**Re: Comments on Remedial Investigation/Feasibility Study ('RI/FS') Report  
BF Goodrich Superfund Site ("Goodrich Site") -- Rialto, California**

**MEMORANDUM**

**Re: RI/FS And Proposed Cleanup Plan  
B.F. Goodrich Superfund Site  
Rialto, California**

**Figure 1 – Extracted from Anderson *et al* and illustrating the location of the Rialto-Colton Fault Zone as determined by Anderson *et al* (RCF) and Dutcher and Garrett (D-G H)**

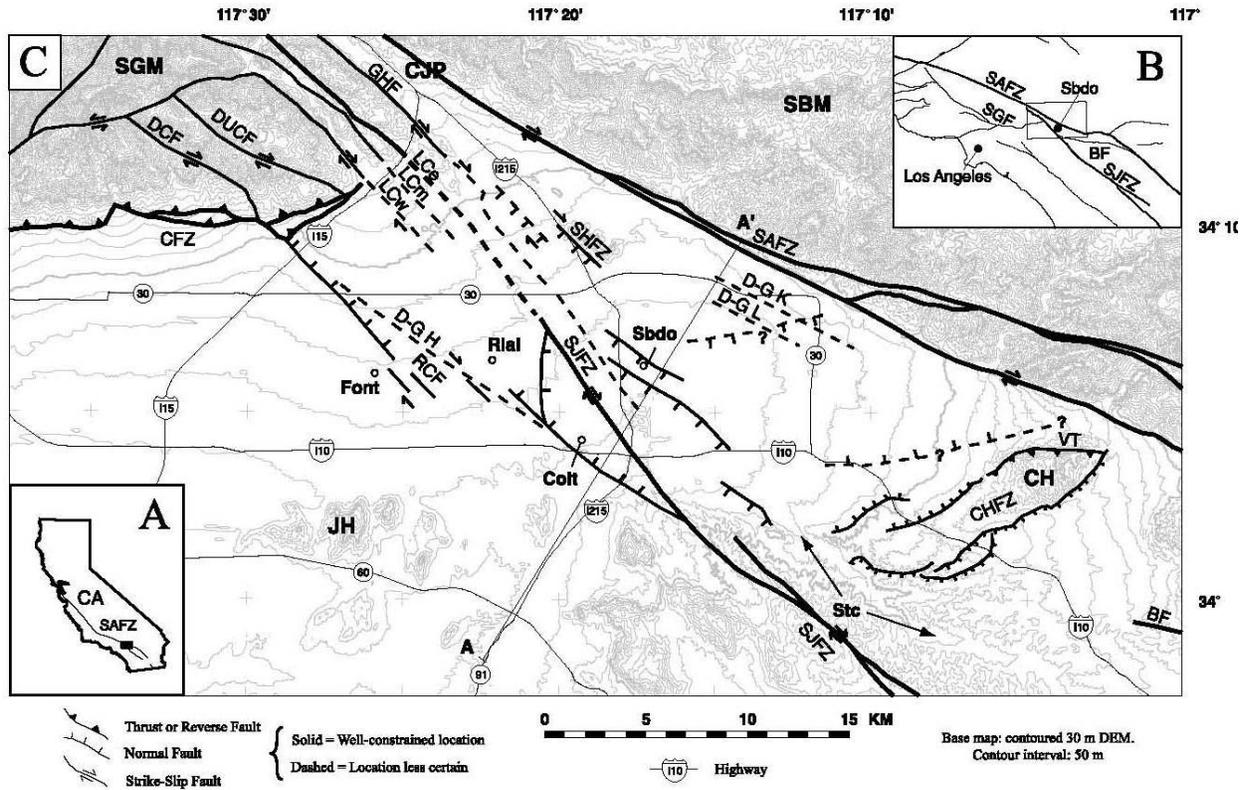
describes the structure of the Rialto-Colton Basin and the bounding faults, it contradicts the basic finding of the Anderson paper in relationship to the location and structure of the Rialto-Colton Fault (RCF). All of the figures in the RI/FS, and the description of the groundwater flow modeling performed for the RI/FS, show the RCF as a continuous impervious barrier to groundwater flow, which the Anderson *et al.* study shows is incorrect, both with respect to the fault location and structure. Furthermore, according to the seismic profiling of the fault area performed by the USGS (Gandhok *et al.*<sup>2</sup>): “Our seismic reflection images show that the Rialto-Colton fault consists of an approximately 1-km-wide zone of small-offset (approximately 20 to 30 m) faults in the upper 1 km depth. No single large-offset fault was imaged along any of the seismic profiles.”

**Figure 1**, below, is extracted from the Anderson paper and illustrates clearly the difference in location of the RCF Zone, as determined by the Gandhok and Anderson work and the prior location of the fault, as depicted by Dutcher and Garrett<sup>3</sup>. A review of Plate 1 from Dutcher and Garrett actually shows that the Rialto-Colton Fault and Barrier H form a fault zone (in congruence with the findings of Gandhok *et al.*), as opposed to a single continuous RC fault and shorter Barrier H, as depicted in the RI/FS. The basic difference between Anderson *et al.* and Dutcher and Garrett is in the location of Barrier H and the structure of the Rialto Colton Fault (see further discussion below regarding the placement of Barrier H).

In addition to the misrepresentation of the Rialto-Colton Fault Zone (RCFZ) and Barrier H, the EPA modeling assumes that the northwestern section of the RCFZ is impervious, which is contrary to the fact that at least four hydrogeological maps of groundwater contours in the northern Chino Basin indicate flow through this section of the RCF Zone.

**FIGURE 2 – Extracted from RI/FS Figure A-8 and modified to show Goodrich and County Landfill sites and correct positions of Wells F10B/C. Schematic streamlines added in red.**

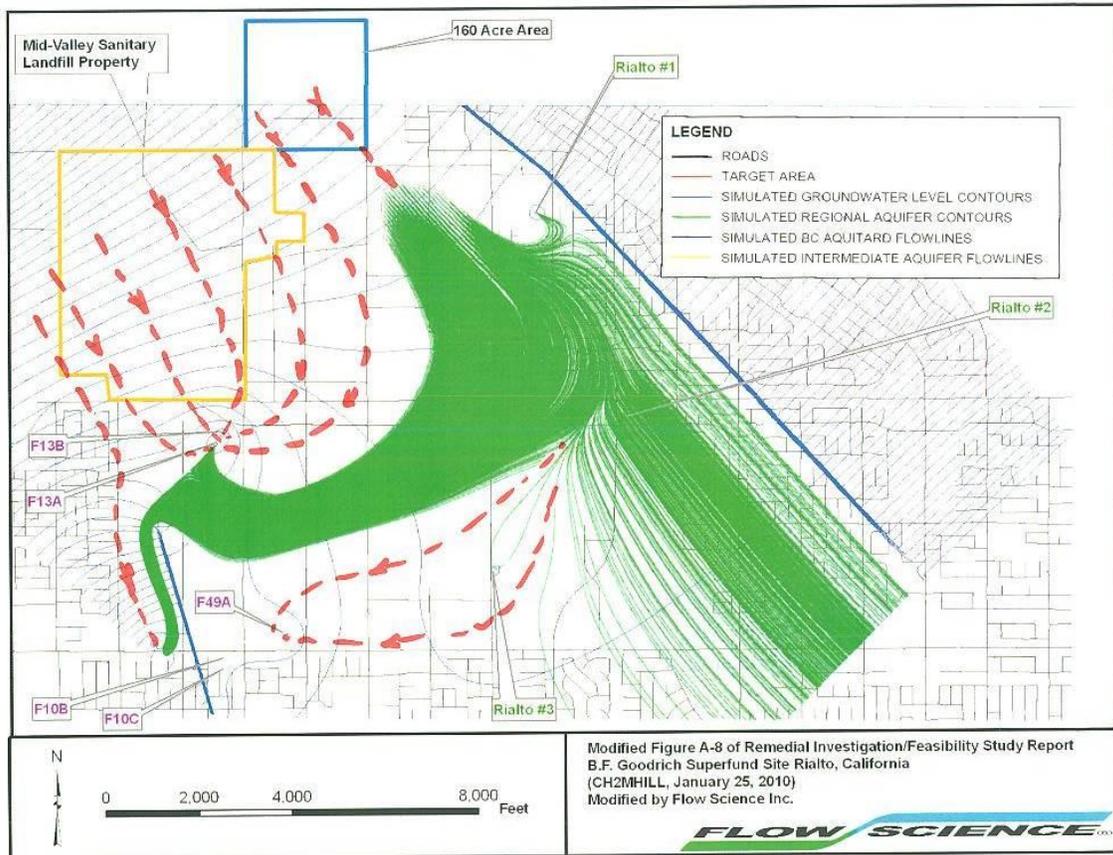
According to Figure A-8 of the RI/FS, included below here as **Figure 2**, (and all of the other RI/FS figures that address 2004 groundwater flow conditions) the operation of the Fontana Water Company wells, particularly its well F49A treating County VOCs, appear to impact the groundwater streamline patterns. Since these are the conditions that will likely be in place for the foreseeable future this is a very important finding. If the modeling is to be believed (and there is good reason to doubt that it can be, as discussed below), this figure and all the others for 2004 conditions show that the streamline patterns for flow into the County planned remediation well Rialto #3 actually do not derive from the County site and that this well will not remediate the County's contamination. The original figure from which **Figure 2** was derived (RI/FS Figure A-8) does not plot streamline patterns that pass through the MVSL and so to illustrate the point streamline patterns based on the groundwater contours have been sketched onto the map, together with the location of the MVSL. From this figure it can be seen that no streamlines through the MVSL enter Rialto #3 and furthermore, it appears that the most effective remediation wells for the County site will likely be the five FWC wells F13A/B, F10B/C and F49A. Conclusion: both the EPA and County's proposed treatment systems at Rialto #2 and Rialto #3 may remove some of the perchlorate emanating from the Goodrich site, but little or no perchlorate from the County landfill.

EPA's cleanup plan and maps all assume and depict a separate perchlorate plume emanating from the Goodrich site, completely separate from the plume from the adjacent County landfill. But EPA's modeling refutes this untenable separate plume theory. The streamline patterns and particle paths shown in the model results are quite simply incompatible with two distinct contaminant plumes.

While it is understood that the streamline patterns drawn are representative of "steady state" flow conditions, and that in a situation where the flows are changing year-by-year, particle paths do not always coincide with streamlines, the results plotted in **Figure 2** (and the other 2004 remediation scenarios plotted in the RI/FS Appendix A) make it very clear that a proper analysis of the remediation effort must analyze the transient flow conditions and the remediation of the County site in the Cleanup Plan.

**FIGURE 3 – Extracted from RI/FS Figure 1-4. Schematic streamlines added in red.**

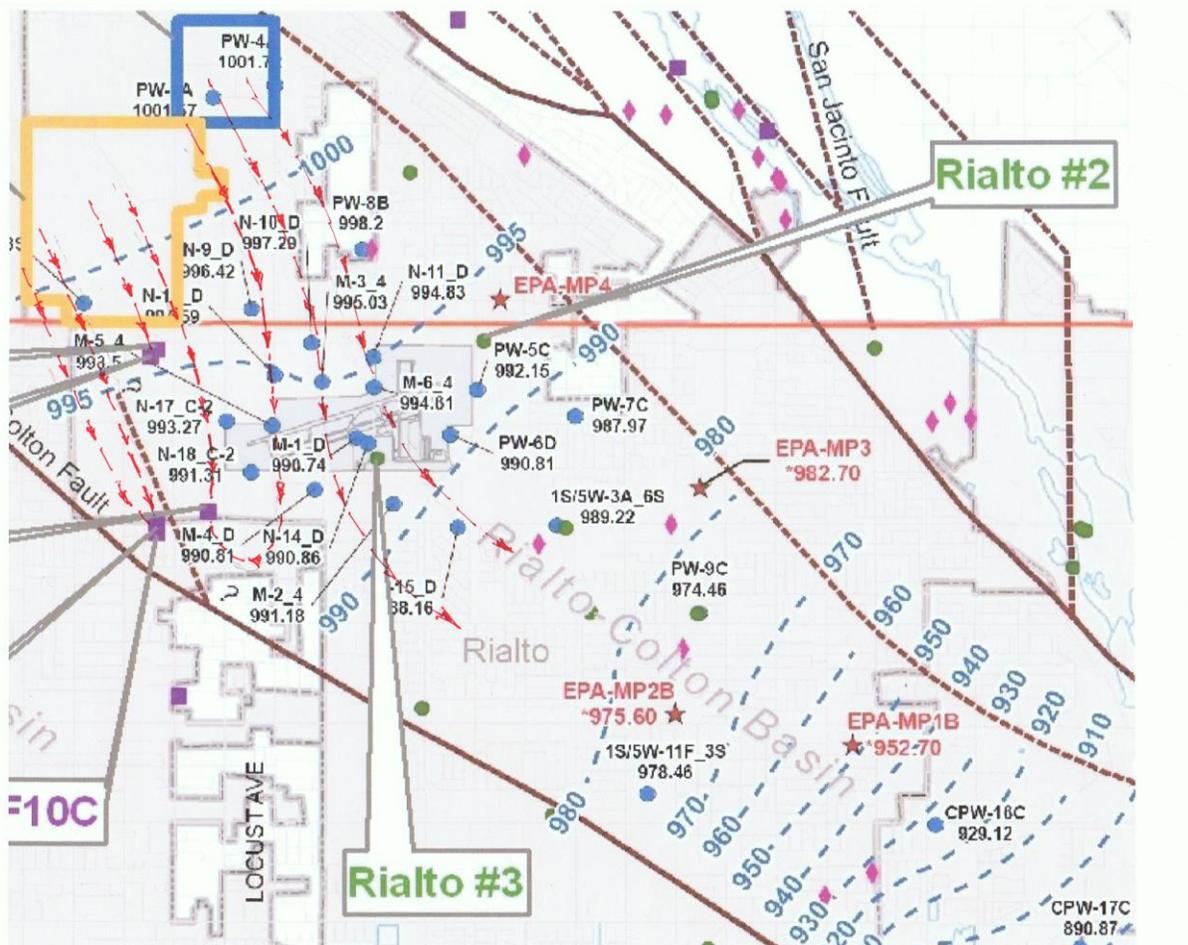
The southwesterly flow of perchlorate is further indicated by the streamline directions implied by the groundwater elevation contours plotted in RI/FS Figure 1-4. **Figure 3** below has been extracted from EPA Figure 1-4 to emphasize the groundwater contours not plotted between elevation 990 and 995. Streamlines inferred from these groundwater contours (plotted in red in Figure 3) clearly show transfer of perchlorate from the County site to FWC 13A/B, which is confirmed by the high fraction of synthetic perchlorate observed in well F13A during the recent preliminary chlorine and oxygen isotope studies. The plotted streamlines also indicate possible transfer of perchlorate from the Goodrich site to FWC well F49A. (Note that this figure also indicates the correct positions of FWC wells F10B/C, which are incorrectly placed in RI/FS Appendix figures, as discussed in more detail below.)

Note also in **Figure 3** that the measured groundwater contours, and their associated streamlines that transport perchlorate to the FWC wells F13A/B, F10B/C and F49A (the purple squares on the map), agree in general form to those streamlines and contours in the same area shown in **Figure 2**.

**FIGURE 4 – Extracted from RI/FS Figure 1-5 to show extent of plume east of Rialto #2.**

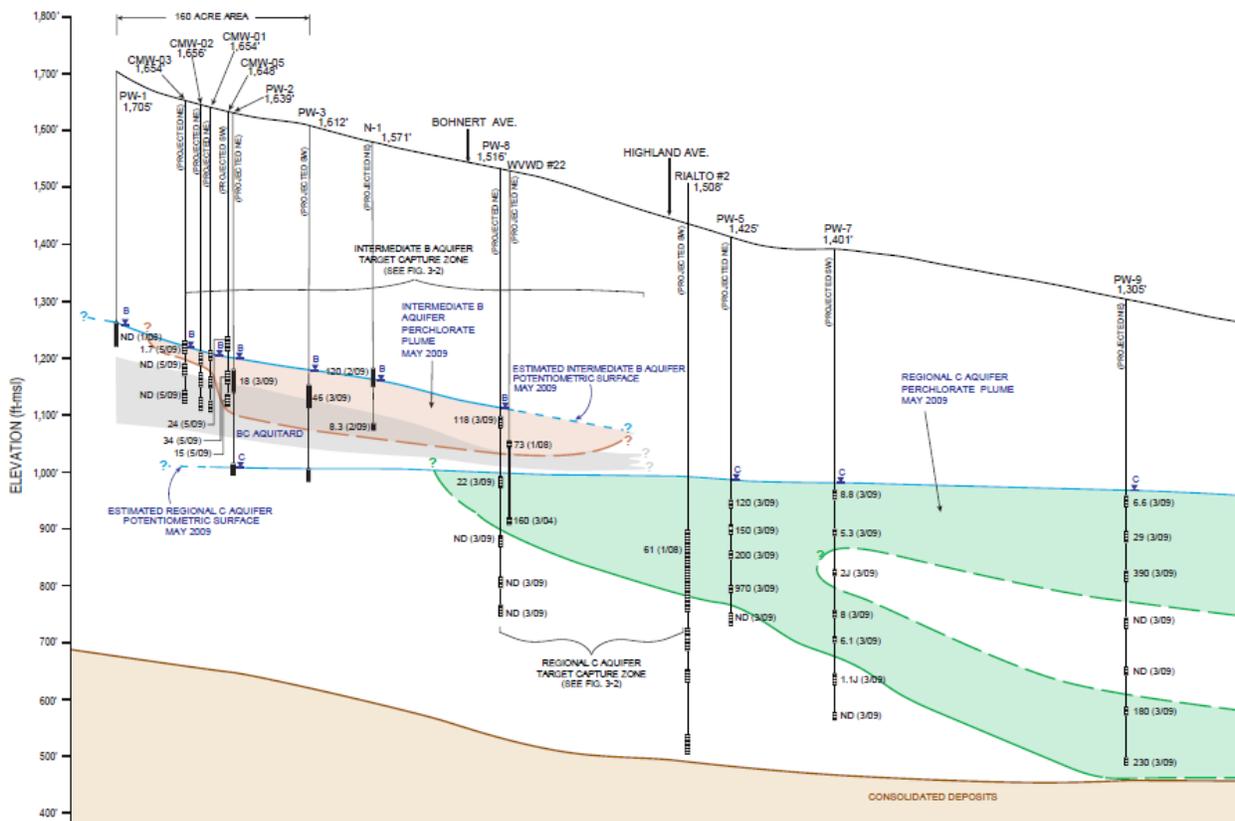
The proposed Cleanup Plan relies upon two interception wells Rialto #2 and a new well EW-1, located to the west of Rialto #2, as shown in RI/FS Figure 3-6. However, referring to RI/FS Figure 1-5, included here as **Figure 4**, it is clear that a huge volume of perchlorate contaminated groundwater lies hydrogeologically downstream of Rialto #2 and that the Cleanup Plan will have no impact on the removal of this polluted groundwater flow stream. Concentrations of perchlorate in this downstream plume exceed 300 ppb of perchlorate (Rialto #6). The Cleanup Plan should address how this plume of perchlorate is going to be intercepted and treated.

**FIGURE 5 -- Sections of RI/FS Figures 1-4 and A-8 in an overlay showing misplacement of Wells F10B/C and Barrier H. Figure also includes County and BROCO sites.**

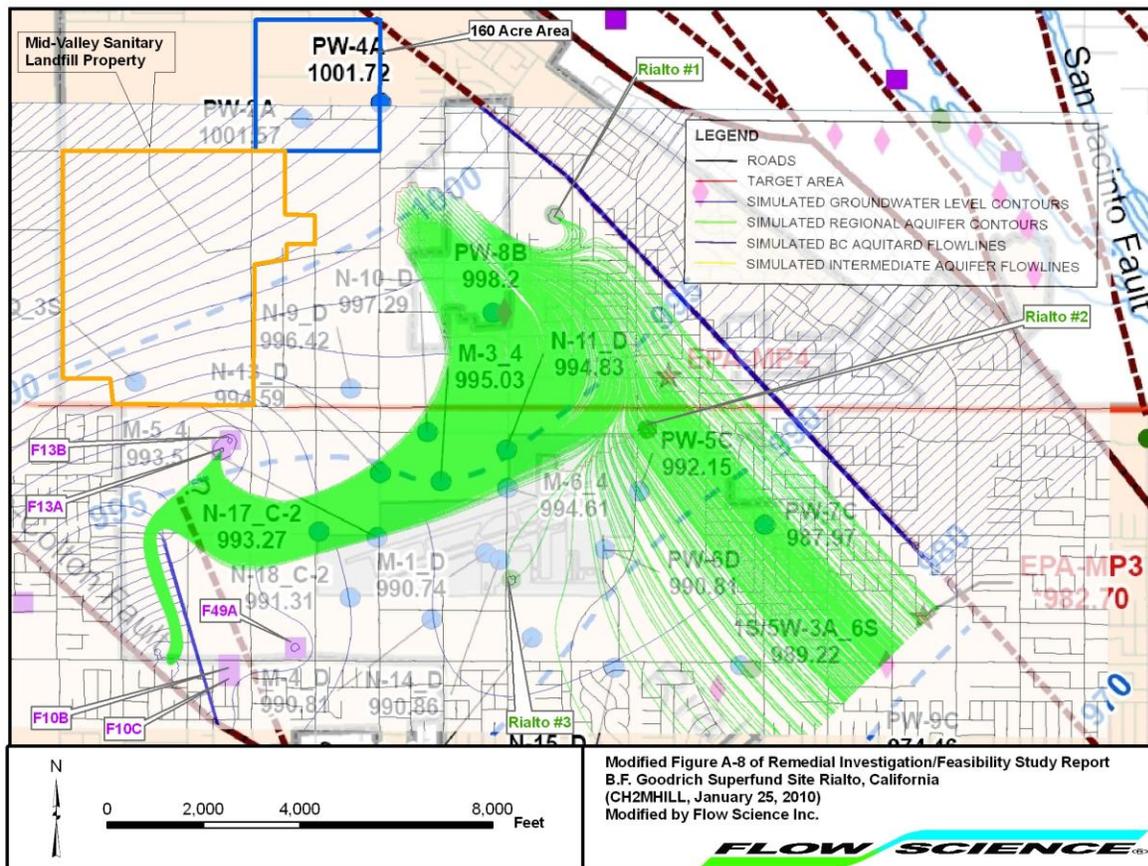
(i) The presumed position of Barrier H and the locations of FWC wells F10B and F10C are incorrectly positioned in the groundwater model. **Figure 5** below is an overlay map created by Flow Science with a GIS system using Figures 1-4 and A-8 from the RI/FS. In the lower left hand corner of this figure two different locations for Barrier H can be seen. One shown as a dark blue solid line, as in Figure A-8, and the other a dotted light brown line, as in Figure 1-4. Wells F10B/C are not explicitly called out in Figure A-8, but their location is implied by the apex of the green particle paths. In Figure 1-4 these two wells are shown as overlapping light purple squares. Flow Science has checked the actual locations of Wells F10B/C and has marked these locations on **Figure 5**; they coincide with the locations shown in RI/FS Figure 1-4. The fact that Barrier H and the Wells F10B/C are apparently mislocated in the groundwater model will obviously change the computed groundwater contours and streamlines; how significant the change will be is difficult to assess without rerunning the model with the correct geometrical data.

Perhaps even more important than the mislocation of Barrier H is the presumption of its shape and impermeability. Given the uncertainty associated with both the location and structure of this “barrier” it would have been entirely appropriate to have performed model sensitivity analyses that omitted the barrier altogether.

**Figure 6a – Groundwater elevation and perchlorate in sample well PW-2 Goodrich site.**

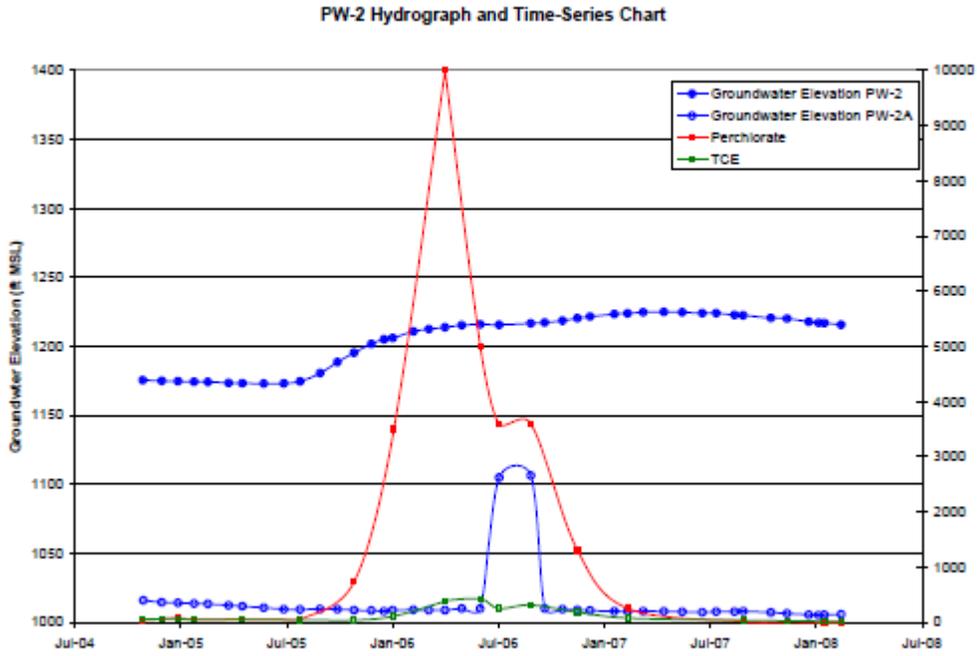
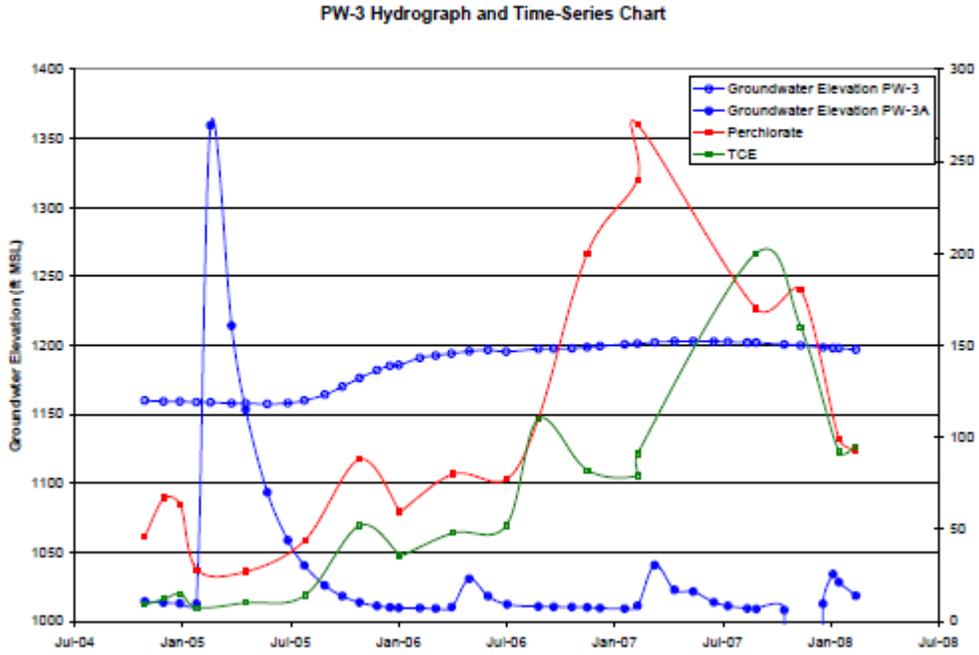
However, as shown in the field data from the Goodrich site (**Figures 6a and 6b**) the water levels do not remain constant, and it is these changing water levels that give rise to the pulses of high concentration perchlorate in the groundwater. In the absence of any transfer from the Intermediate to the Regional Aquifer, where do the high concentrations in the Regional Aquifer come from?

**FIGURE 7 – Validation of the model versus City of Rialto wells.**

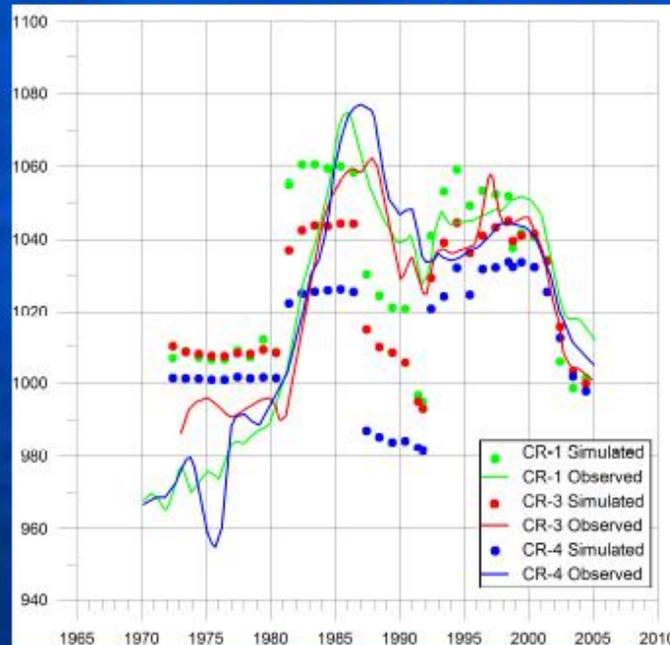
(iii) The attempted validation of the modeling as represented by RI/FS Figure A-6 (see **Figure 7** below) shows a poor correlation with measured groundwater surface elevations in City of Rialto wells with elevation discrepancies of as much as 70 ft and also indicating groundwater slopes during the 1980's that are not present in the well data. In fact, the RI/FS concedes that the model even indicated flows out of the northwest boundary of the modeling region in the late 1980's and 1990's —basically saying that groundwater ran uphill! (See RI/FS Figure A-7a included here as **Figure 8.**)
